ADDENDUM #1

Rye City School District

Issued for Bid: 2021-01-29

This Addendum No. 1 forms part of the Contract Documents and modifies the original bidding documents dated, January 19, 2021.

DATE:	01/19/2021
PROJECT No:	9200
DRAWING BY:	JP
CHK BY:	AP
DWG No:	HSMS-ASB-101

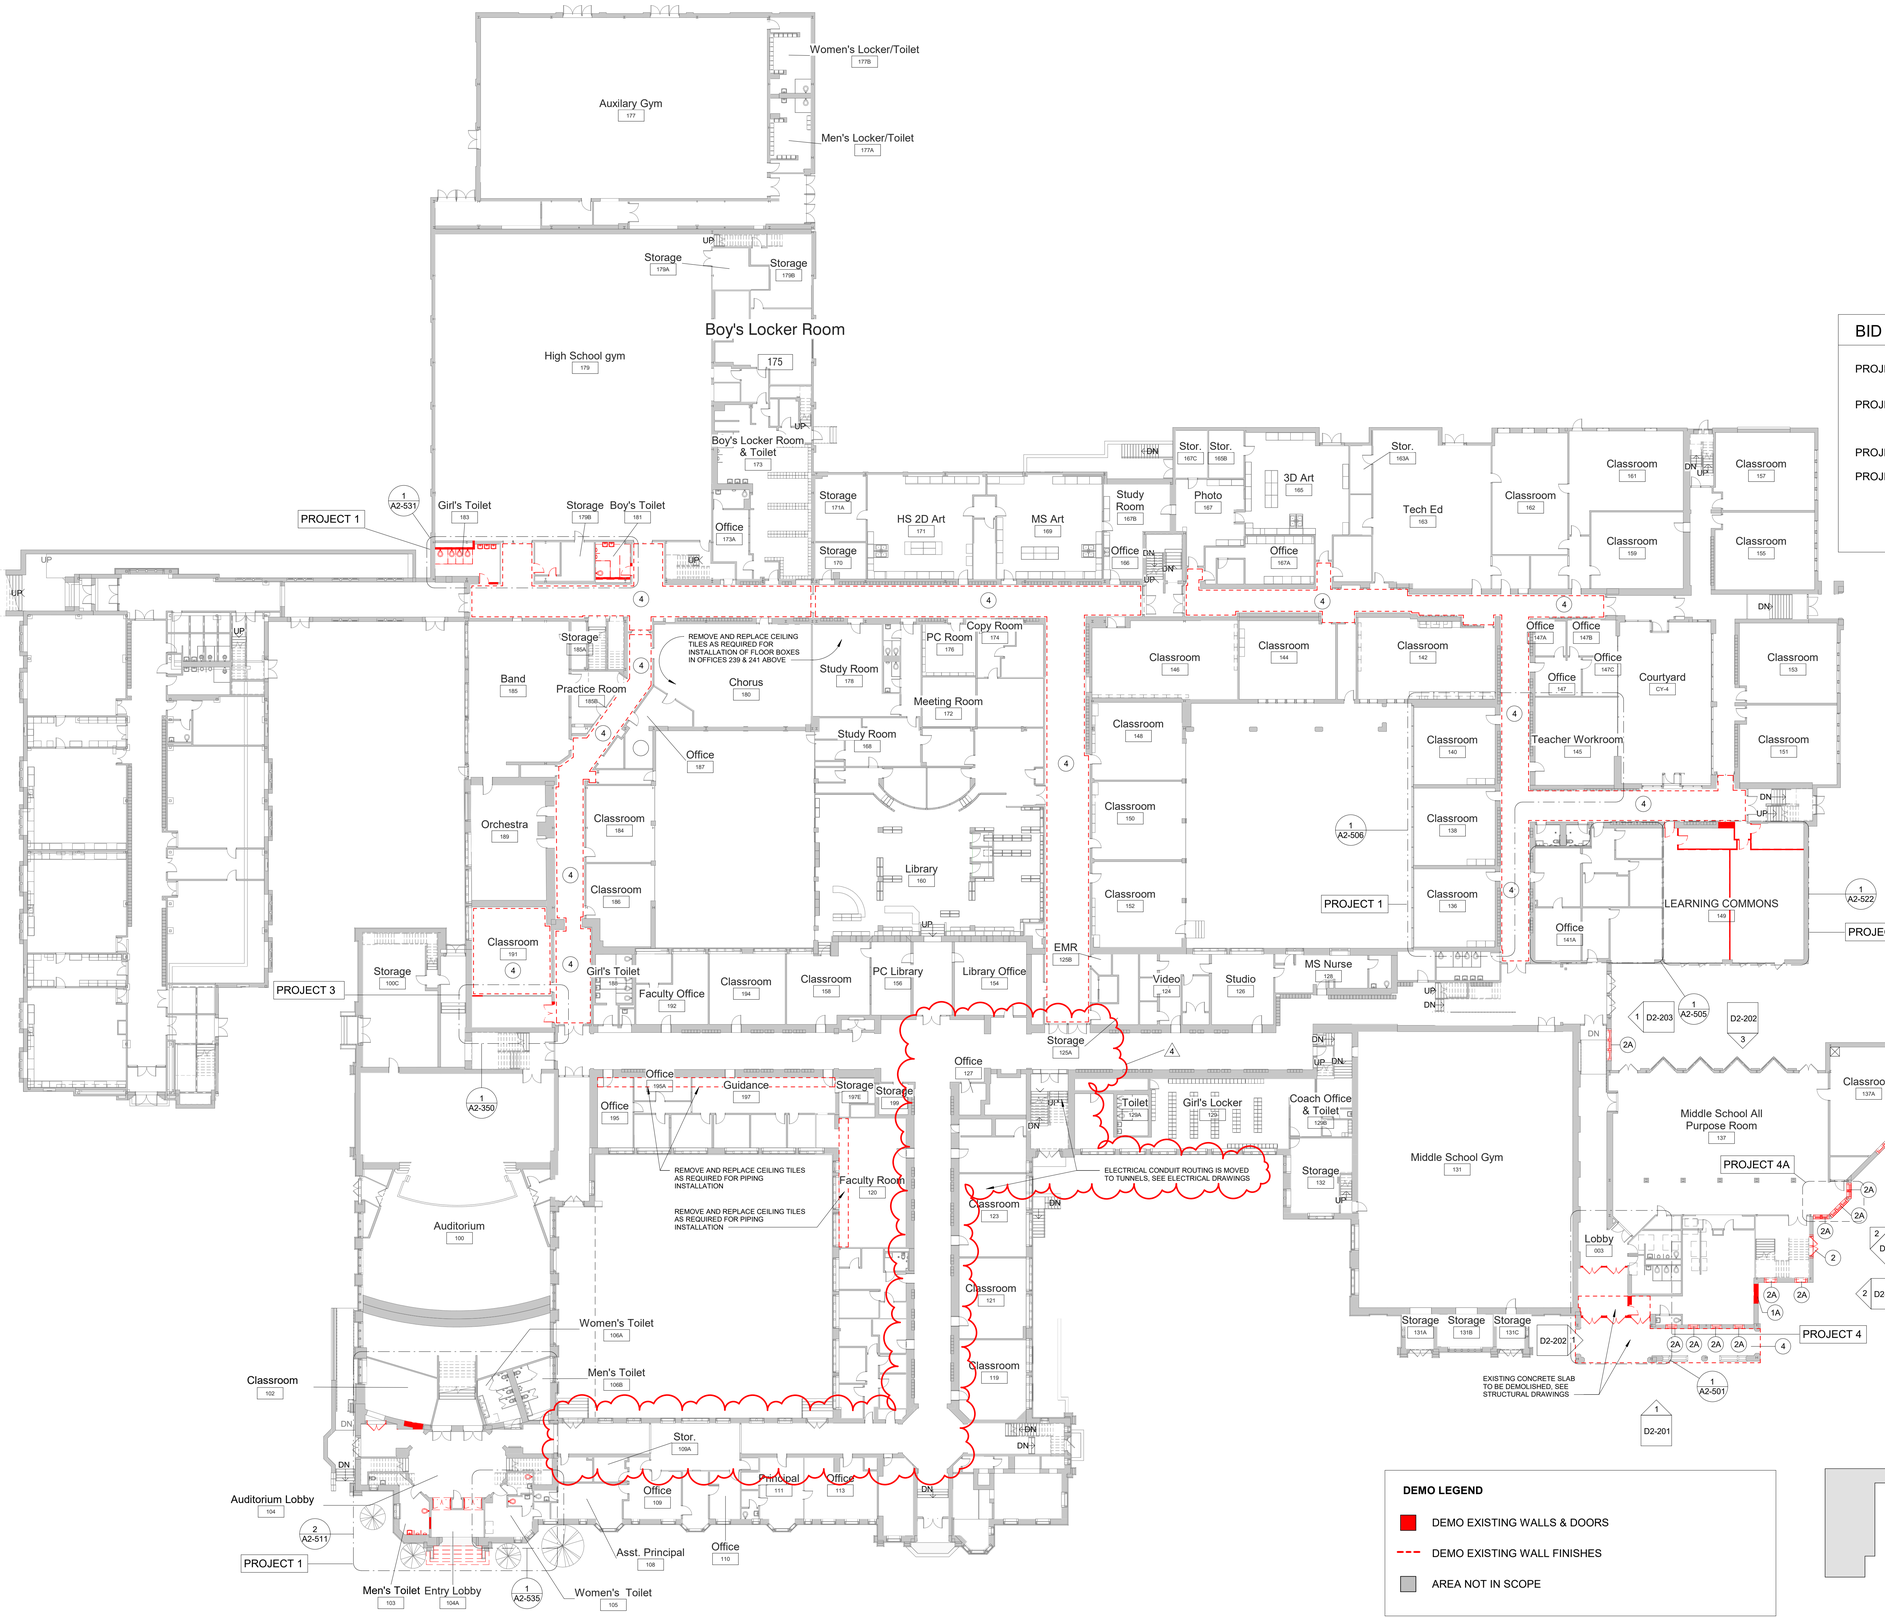
7. HSMS-ASB-101:
    a. Add Removal identification numbers 7 & 8, with associated notes. Changes are bubbled on drawing.

DATE: 11/04/19
PROJECT No: 9200
DRAWING BY: Author
CHK BY: Checker
DWG No: A2-511

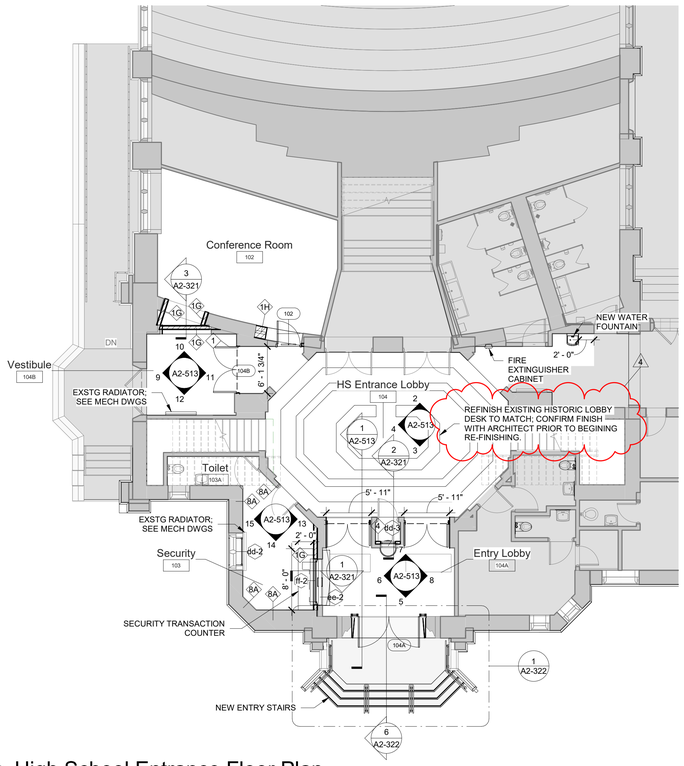
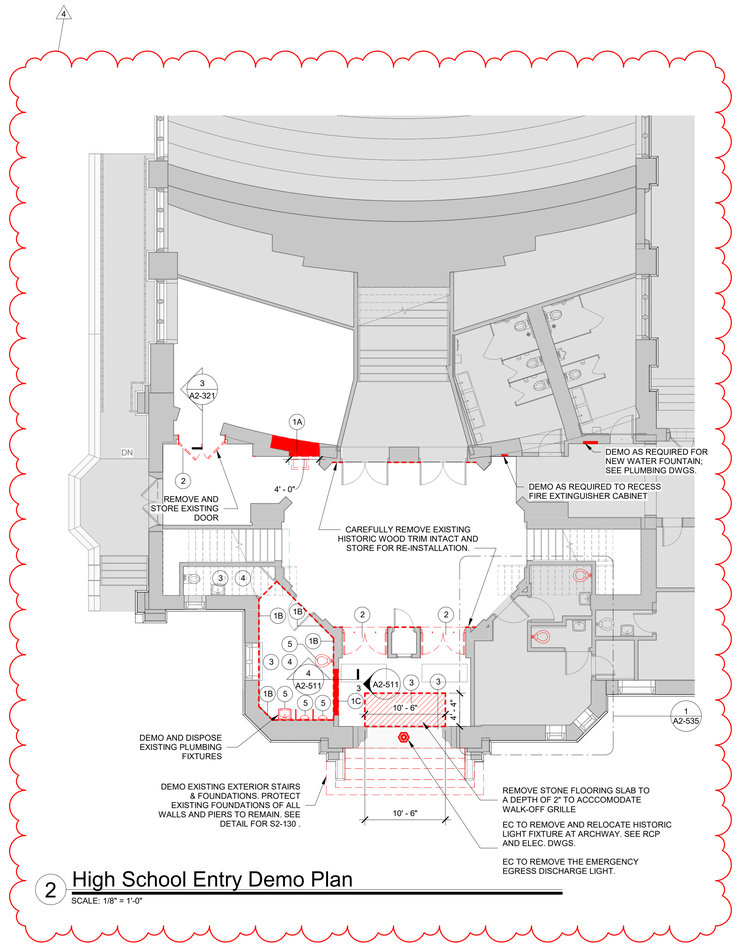
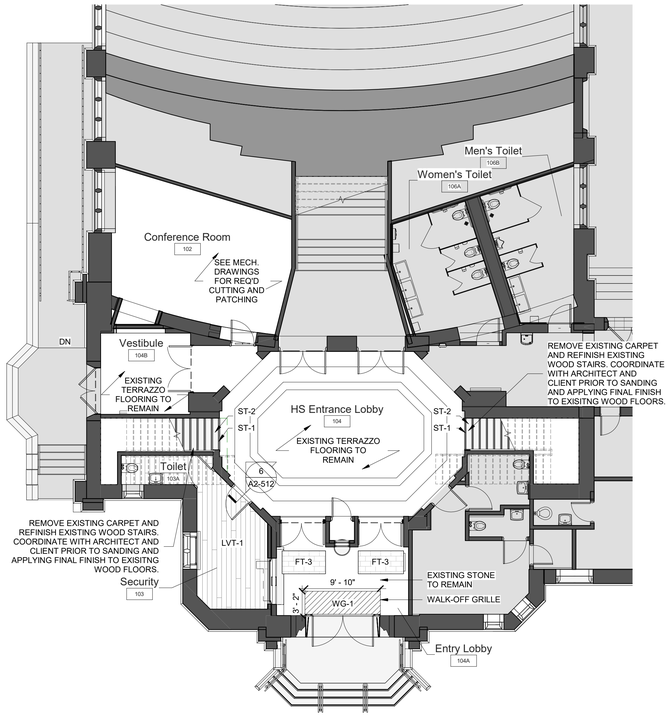
10. A2-511:
    a. Detail 1: Refinish existing historic lobby desk.
    b. Detail 2: Revise extent of demolition of existing wall finishes as shown.

DATE: 06/12/20
PROJECT No: 9200
DRAWING BY: Author
CHK BY: Checker
DWG No: A2-512

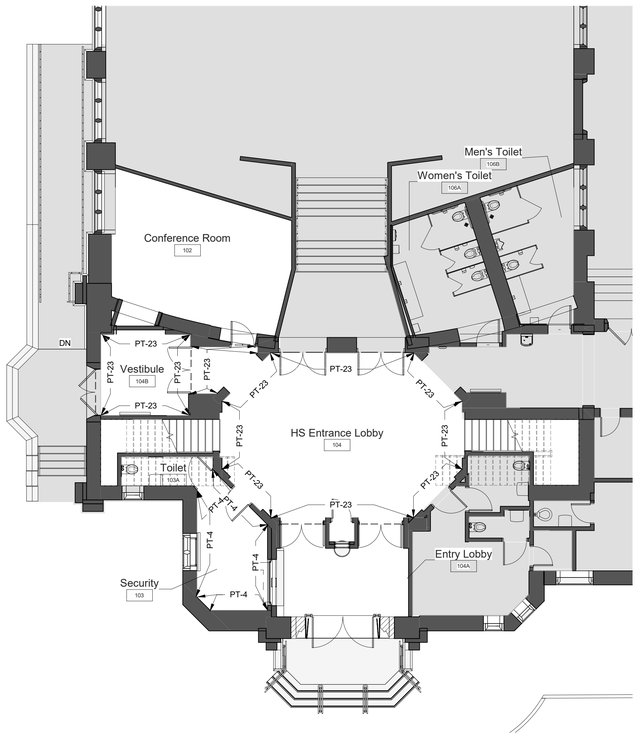
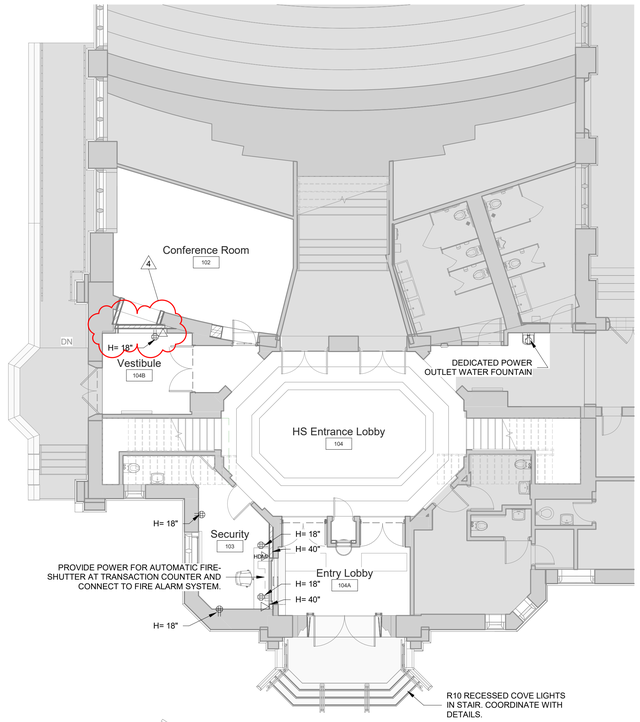
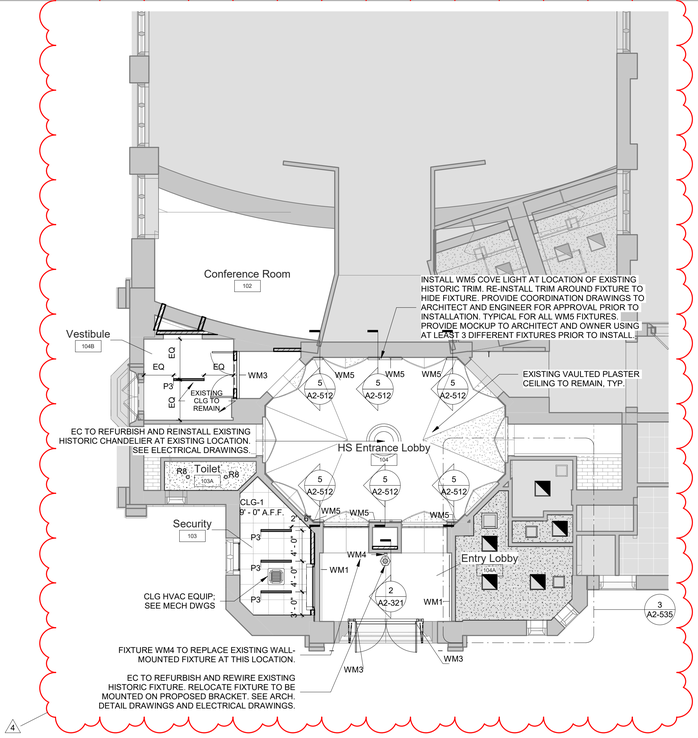
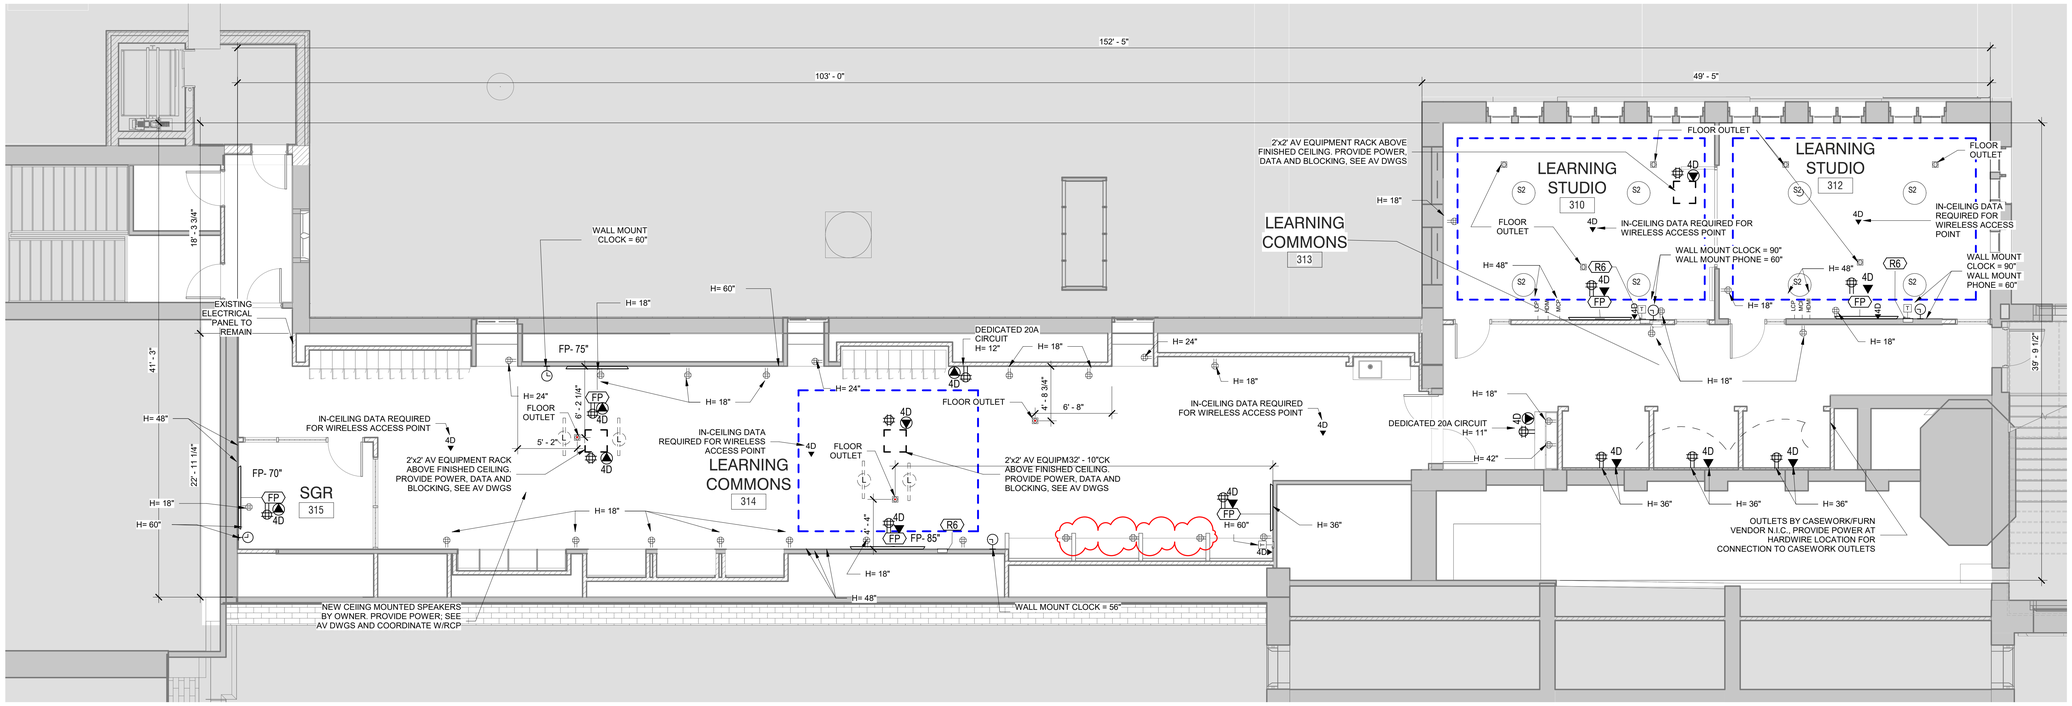
11. A2-512:
    a. Detail 2: Add Power and data at location shown.
    b. Detail 3: Revise extent of layout of hidden cove light in Lobby at trim as shown; Refurbish and reinstall existing historic chandelier in Lobby; add light at new door to vestibule 104B.

DATE: 09/02/20
PROJECT No: 9200
DRAWING BY: Author
CHK BY: Checker
DWG No: A2-517

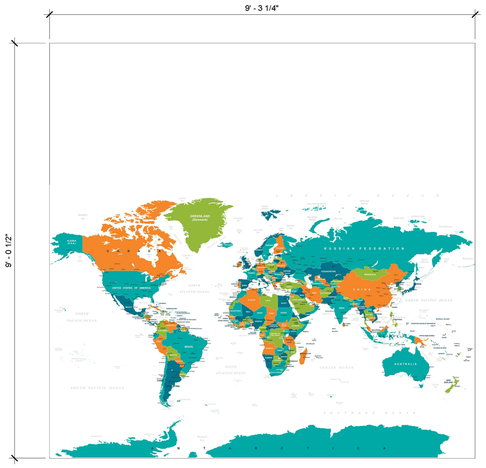
12. A2-517:
    a. Add outlets as shown and coordinate with owner's casework vendor for installation.
